SB-10041995-2177

Title: Realignment of Air Suspension Pressure Sensor

Applies To: Prostars with Advance Brake Systems

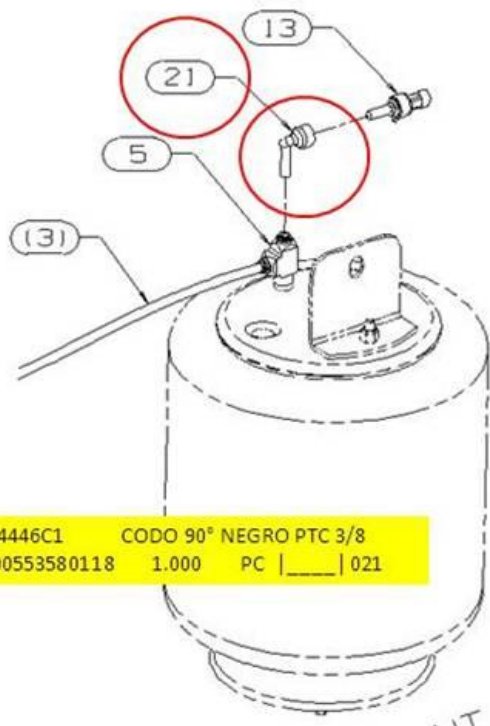
The Air Pressure Sensor may be mounted vertical and needs to be mounted horizontal.

1. Examine the sensor mounting at the left rear air suspension to see if it is mounted vertically.

Remove pressure sensor from vertical mounting. Correct seal placement if needed and clean or replace terminals as required. Obtain item 21 below (2024446C1 - Elbow Quick Connect 3/8" Tube X 3/8" Stem) and install as recommended. Install sensor into added elbow and reattach to harness and secure wiring.
